## **Development Review Comments**

March 14, 2023 PAM2023-00145

## Submission Review Comments 2401 Wootton Parkway – Rockshire Village Center

PROJECT VM1935 FDA-1.0

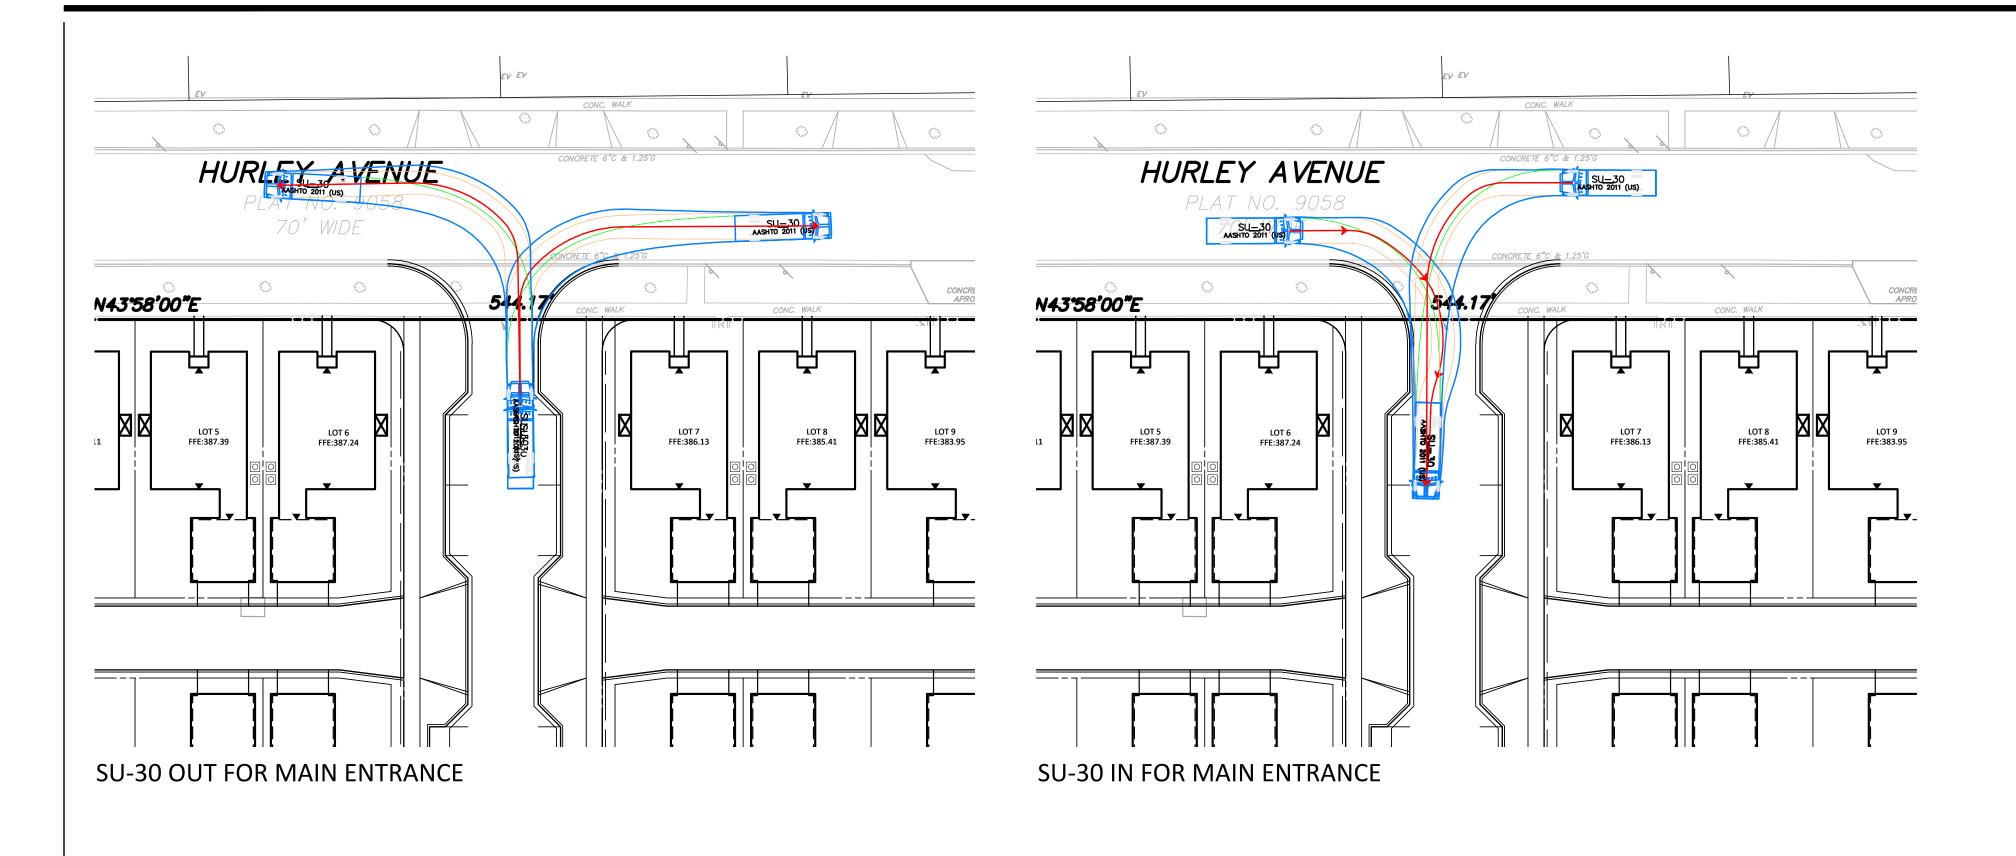
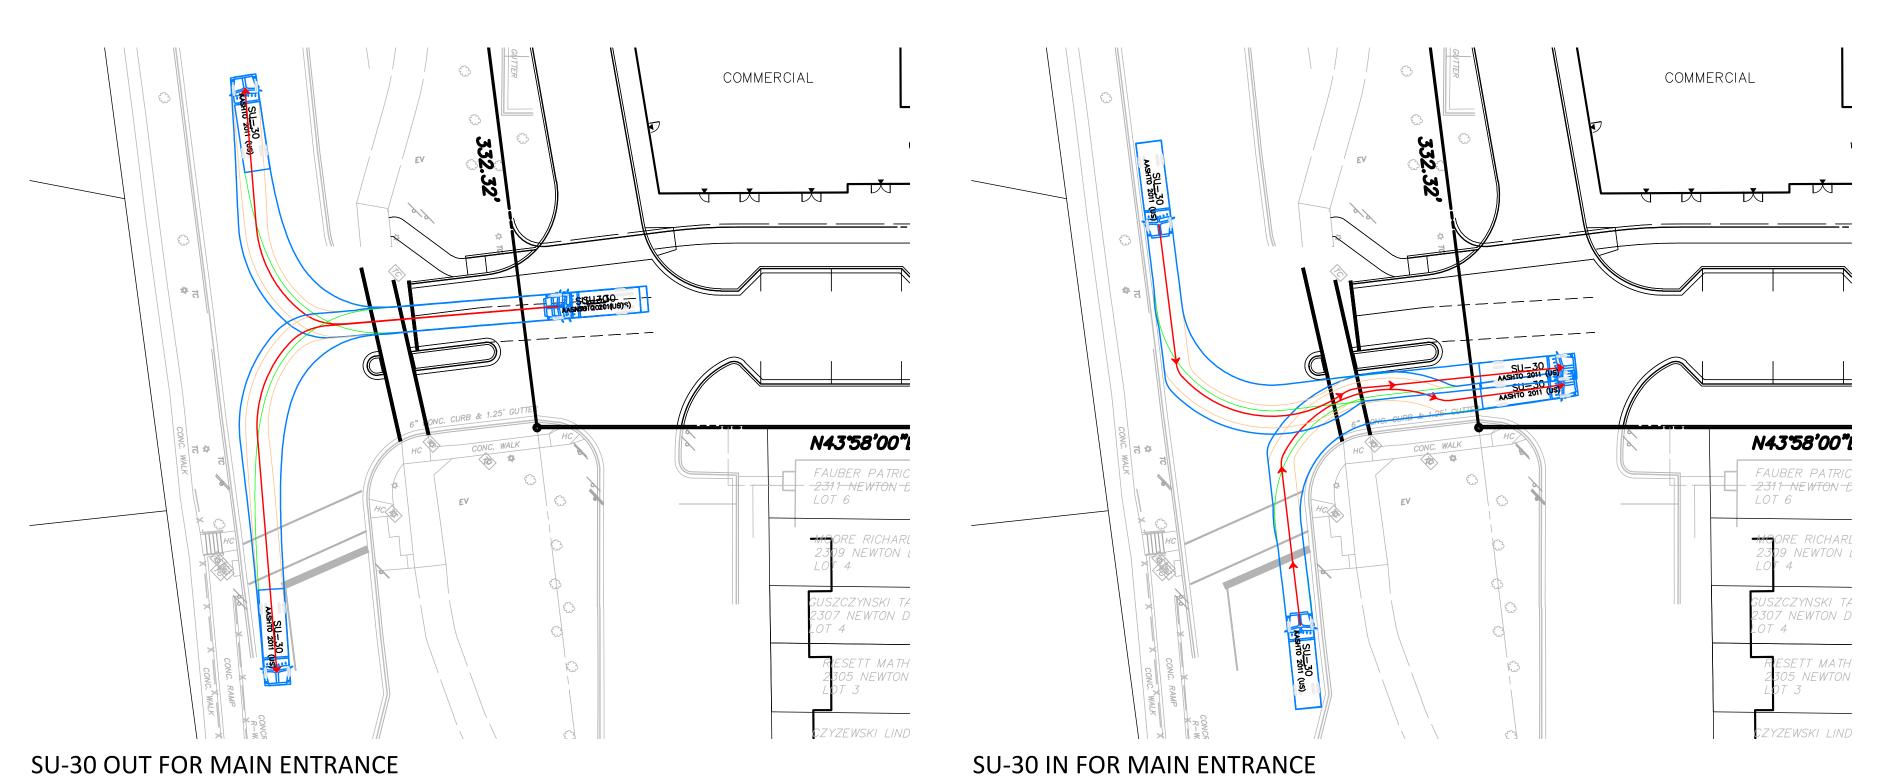
Provide details of the symbols listed on the legend, 10" water line, thick red dash lines, and proposed and existing fire hydrants.

Show the exterior perimeter access path to be walked by fire department

For the proposed commercial building show the exterior perimeter access path to be walked by fire department personnel.

Please show all proposed fire lanes.

Show interior and exterior turning radii for all public streets to be in accordance with CoR amendments to 18.2.3.5.3.1.

Clearly identify the purpose of the red dashed lines shown from the Public Street to the public alley. If the intent is to demonstrate accordance with 18.2.3.2,1.1. please be sure to show the distance directly to an exterior

Provide fire flow water calculations. (Can be submitted at building plan

PROJECT VM1935 DRAWING EXH-5.0.1

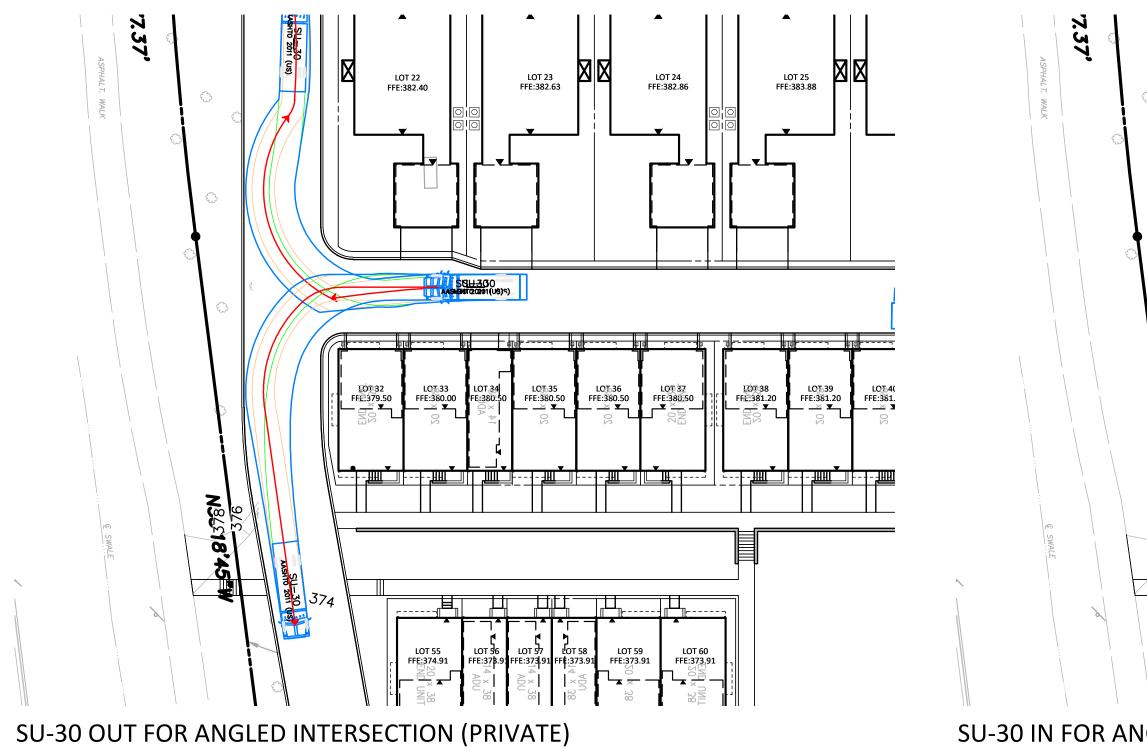
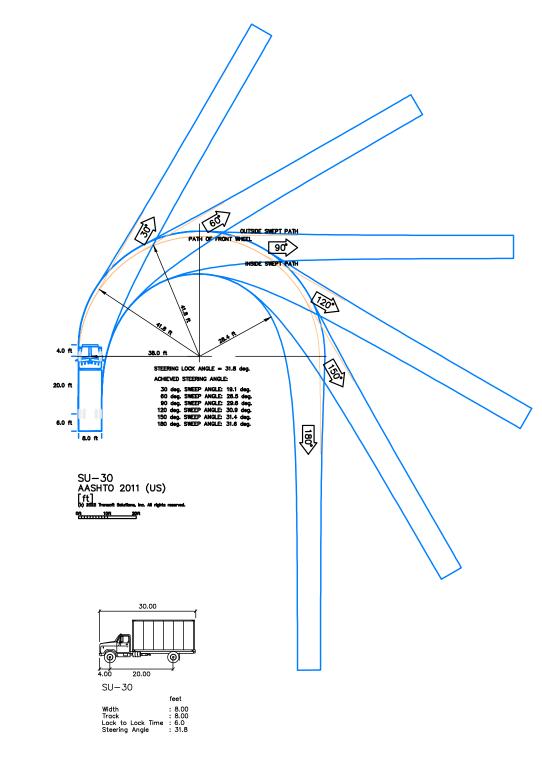
it would be easier to review turning movements for each vehicle type shown collectively on single plan view (rather than separate viewports) **REVISIONS** DATE

EXH-2.0 SHEET NO.

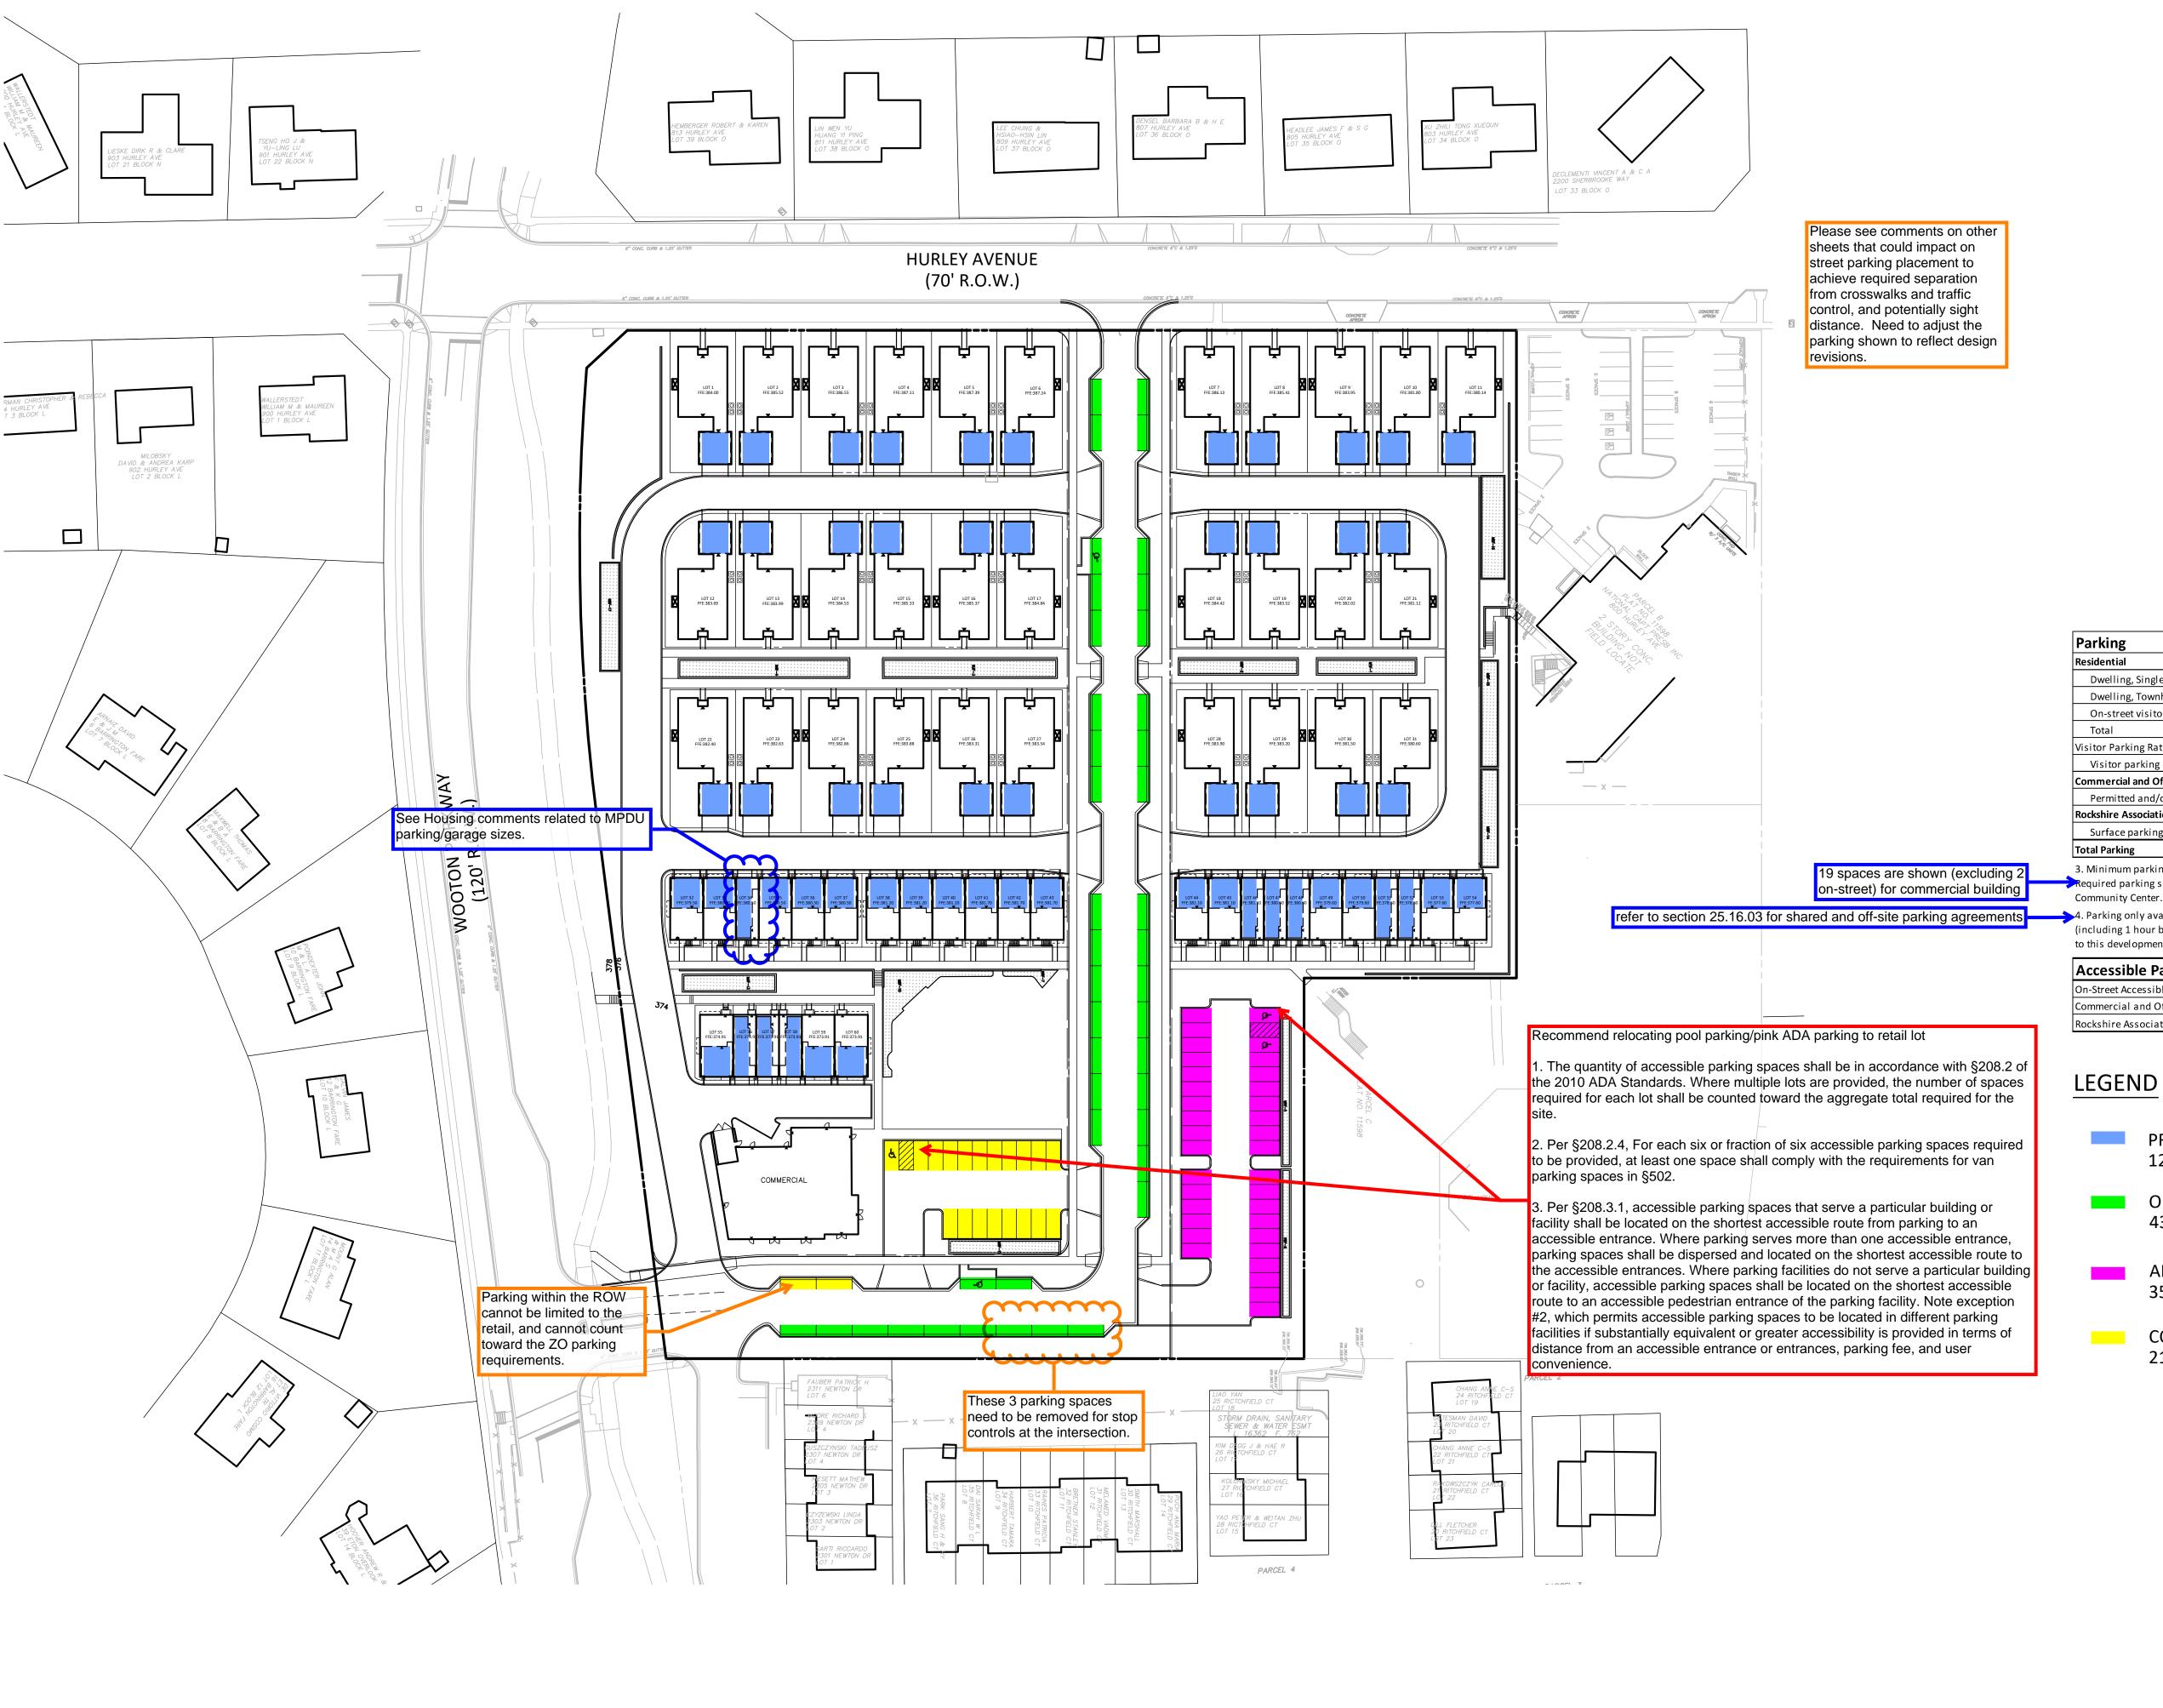
Where is driveway parking proposed? If not proposed, delete legend note
